Re: *Comments of the Massachusetts Port Authority on the United States
Environmental Protection Agency (EPA) Proposed Effluent Limitation Guidelines
and New Source Performance Standards for the Airport Deicing Category
Docket No. EPA-HQ-OW-2004-0038*

**Proposed Rulemaking for Effluent Limitation Guidelines and New Source Performance
Standards for the Airport Deicing Category
74 *Fed. Reg.* 44,675 (August 28, 2009)**

Docket No. EPA-HQ-OW-2004-0038

Massachusetts Port Authority

Figure A. The only area on the Boston-Logan airfield where development or construction would not interfere with runways, taxiways or FAA navigational aids is shown in orange (*i.e.*, the small triangle in the southeast corner of the airfield) and is too small to site a centralized deicing pad.

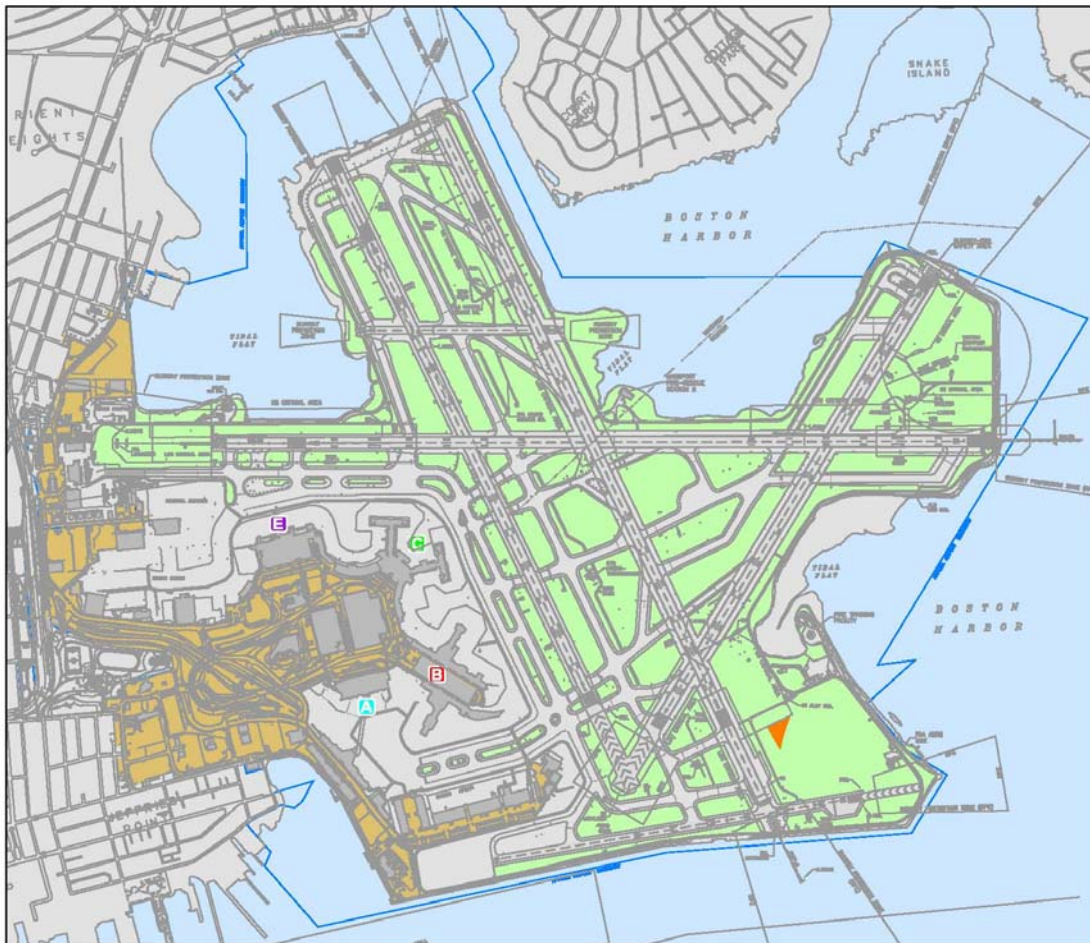
virtually impossible.⁹ Moreover, the existing footprint of Boston-Logan is relatively small given the high volume of traffic it experiences.¹⁰ Indeed, Boston-Logan is the sixth most space-constrained airport in the country based on the number of aircraft operations per acre, as shown in Table 1. Additionally, Boston-Logan's unusual airfield layout, consisting of six different runways and numerous taxiways as shown in Figure 2, leaves virtually no space for new deicing facilities.¹¹ In short, as illustrated in Figure A below, there is only one small, inadequately sized area at Boston-Logan that is available for new deicing facilities.¹²

Figure 1
 Logan Airport Location
 Boston Logan International Airport
 Massachusetts Port Authority
 Capital Programs Dept.
 February 2010

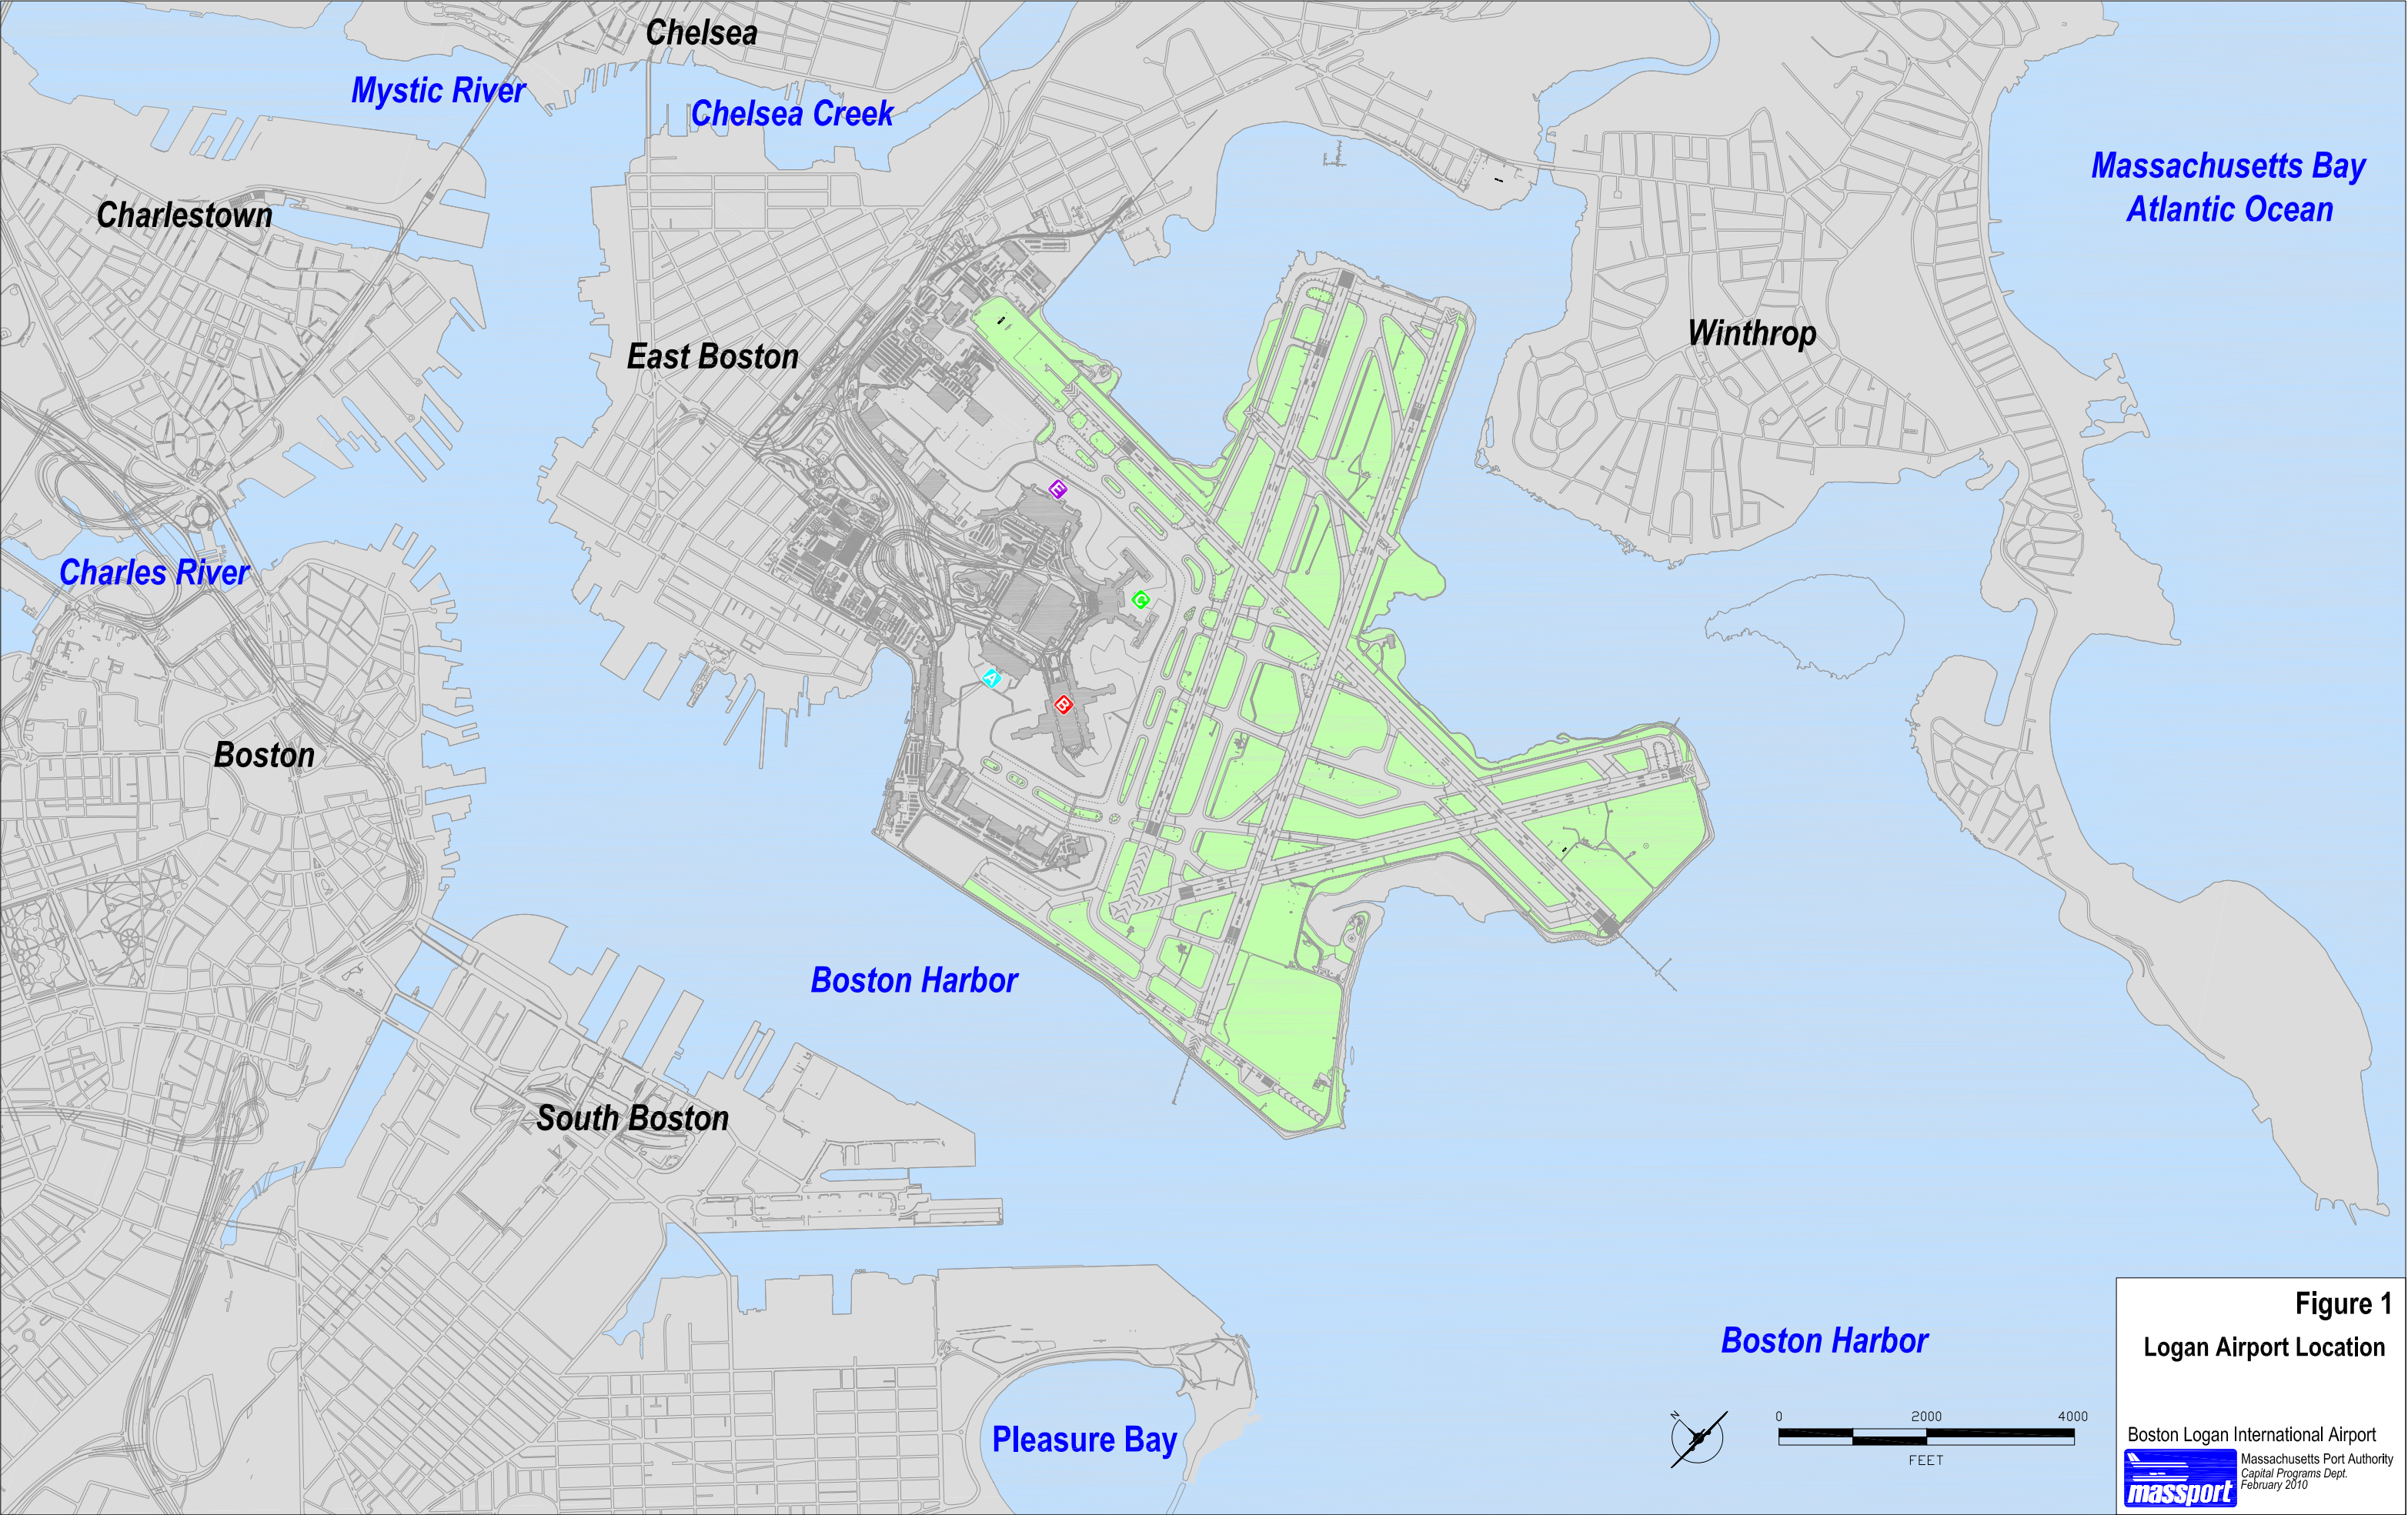
Boston-Logan maintains its position as one of the United States' major airports despite the fact that it is extraordinarily "space-constrained," that is, that there is an extreme shortage of land available for its additional development or expansion. The Airport occupies approximately 1,750 acres of land and is surrounded on three sides by Boston Harbor and a fully developed urban neighborhood on the fourth side, as shown in Figure 1.⁸ This makes geographic expansion

urban neighborhood of East Boston, and is surrounded on its other three sides by, respectively, the waters of Boston Harbor, Boston Inner Harbor and Winthrop Bay, as shown in Figure 1.⁸² Moreover, almost all of the available space at Boston-Logan is already occupied by existing airfield or landside activities, as shown in Figures 2 and 3.⁸³

Figure 5. Boston Logan Average Annual Winds

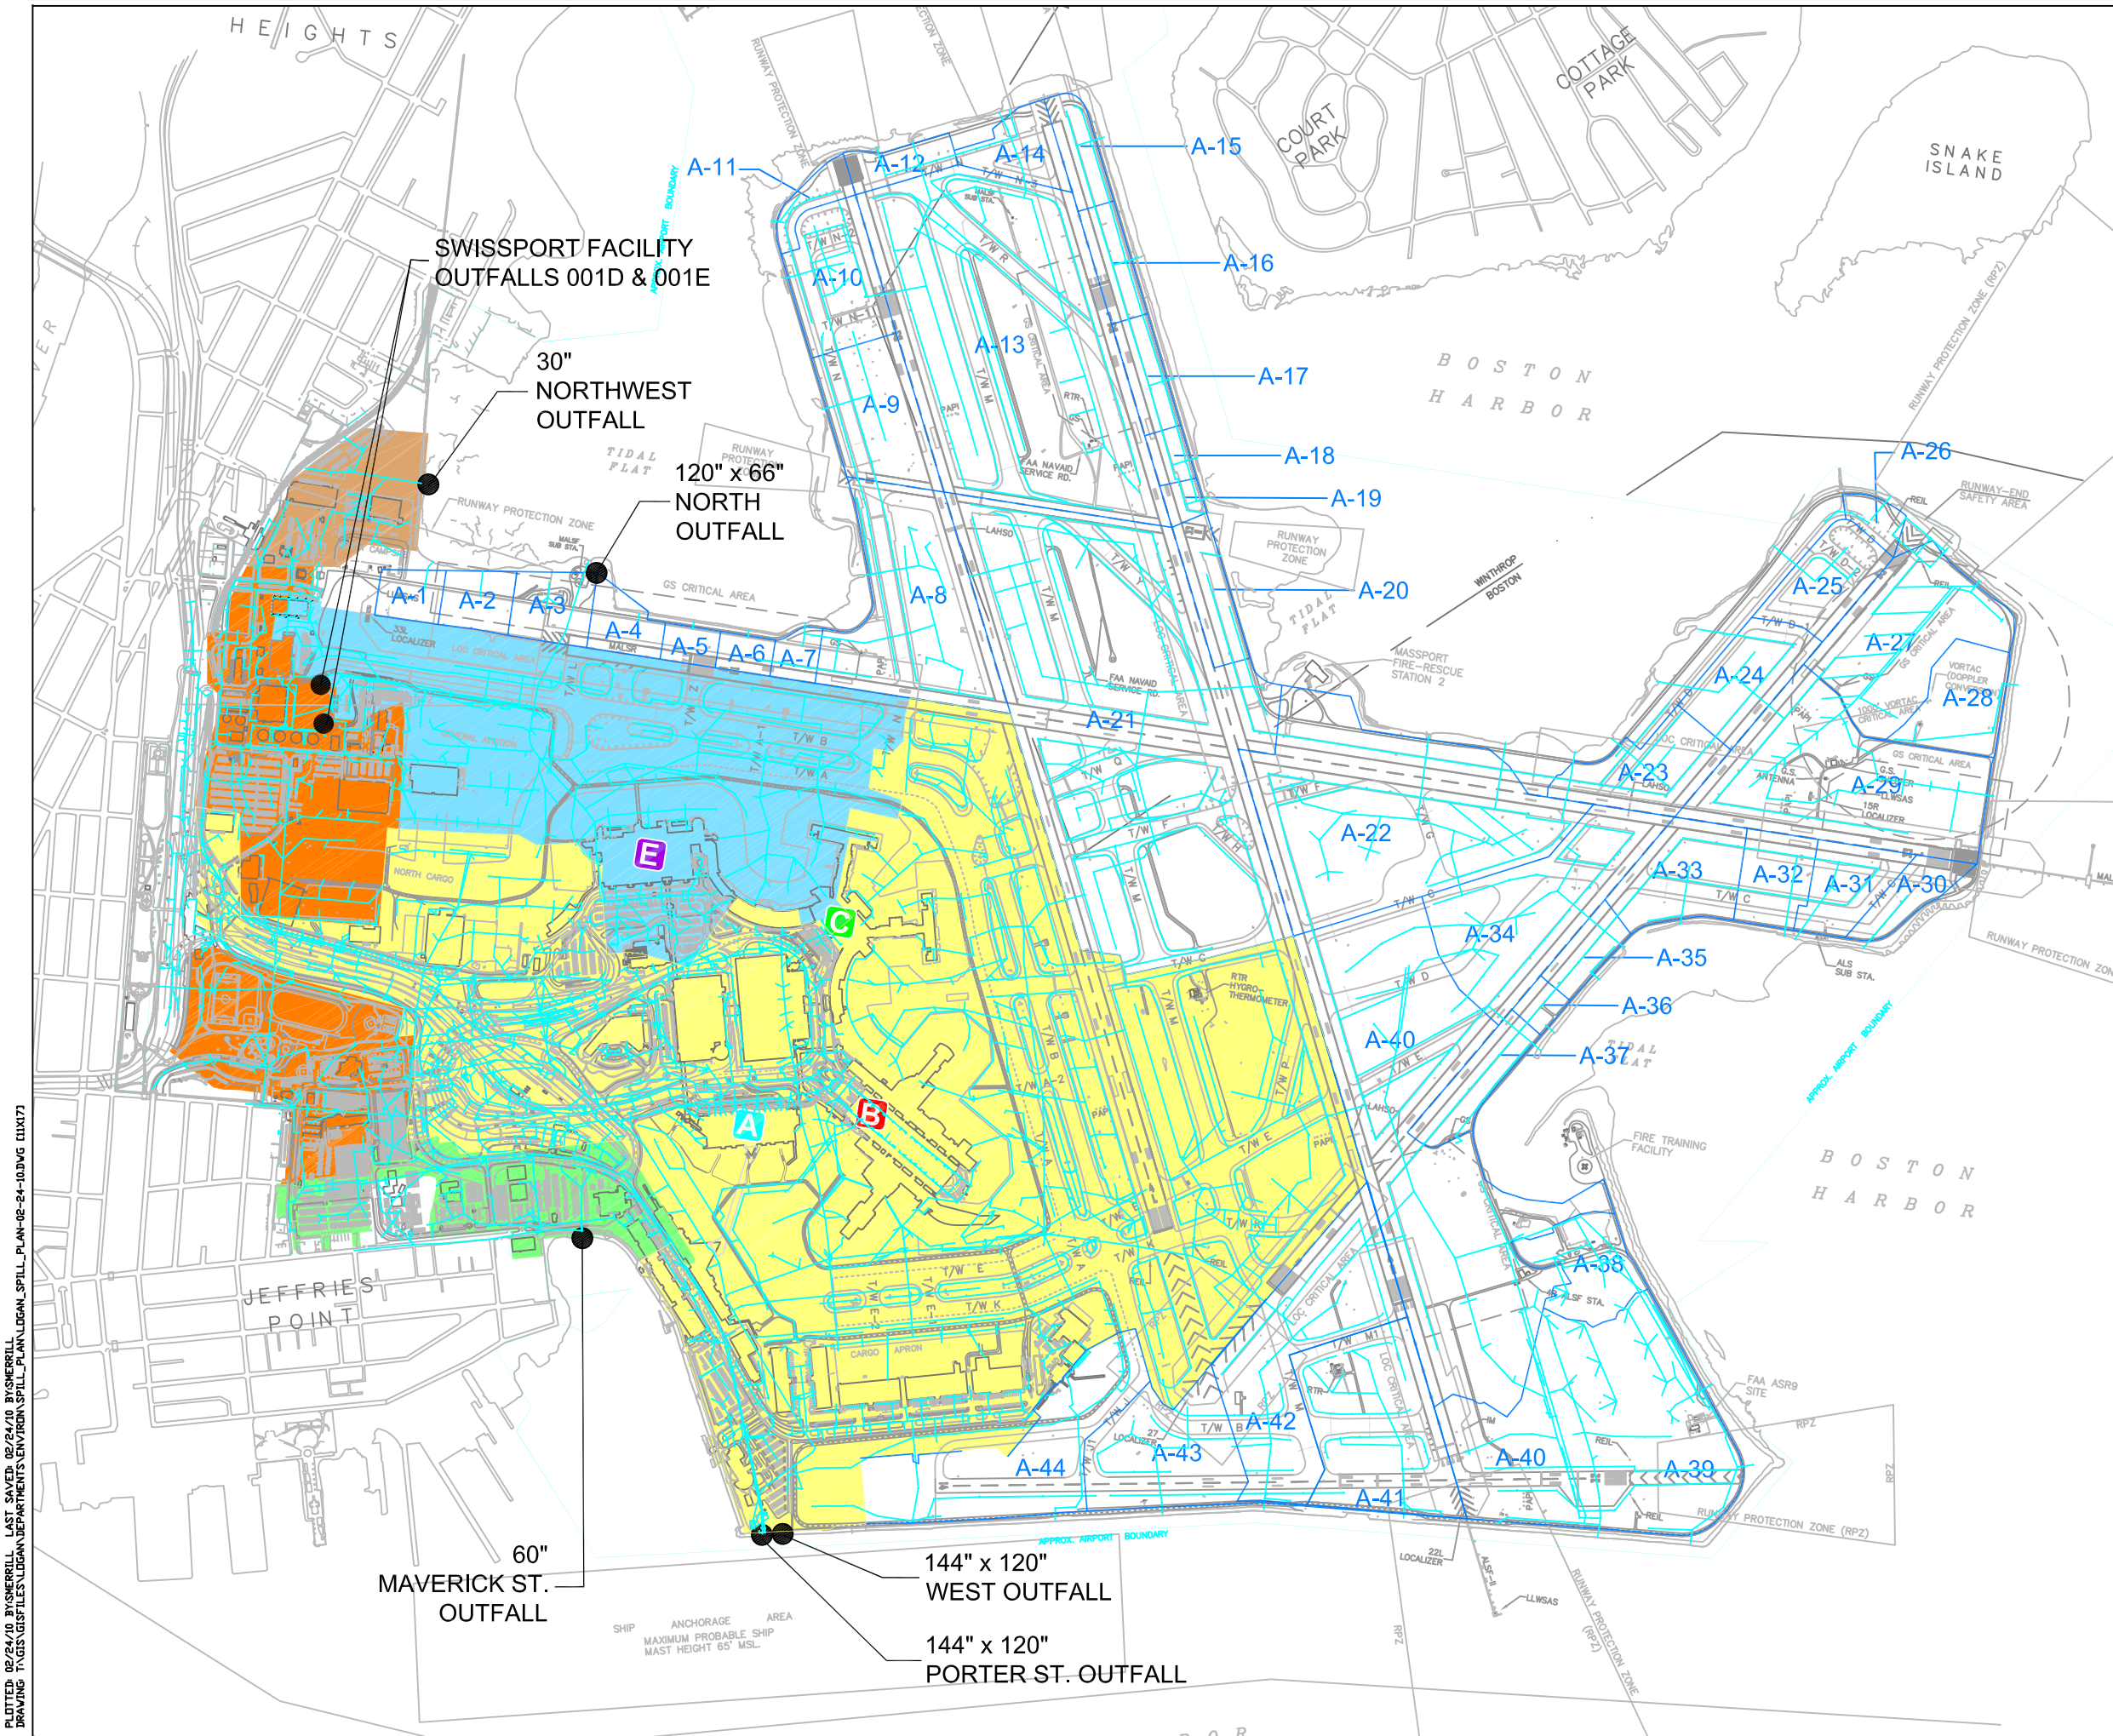
In addition, the wind conditions at Boston-Logan are highly variable, with wind directions ranging around all points of the compass. Figure 5 shows the average percentage of time, over the course of a typical year, during which the wind blows from each of the four quadrants of the compass: 18% of the time, on an average annual basis, from the northeast, 37% from the northwest, 17% from the southeast and 28% from the southwest. This constantly changing wind direction necessitates a more complex airfield layout at Boston-Logan than at airports with less variable wind, with the result that Boston-Logan has six runways, aligned in a total of four directions, as shown in Figure 2.⁸⁴ Moreover, because the land area in which Boston-Logan is located is relatively small and limited to a peninsula, these runways and taxiways necessarily cross each other in many locations, requiring enhanced safety precautions to prevent runway incursions.⁸⁵
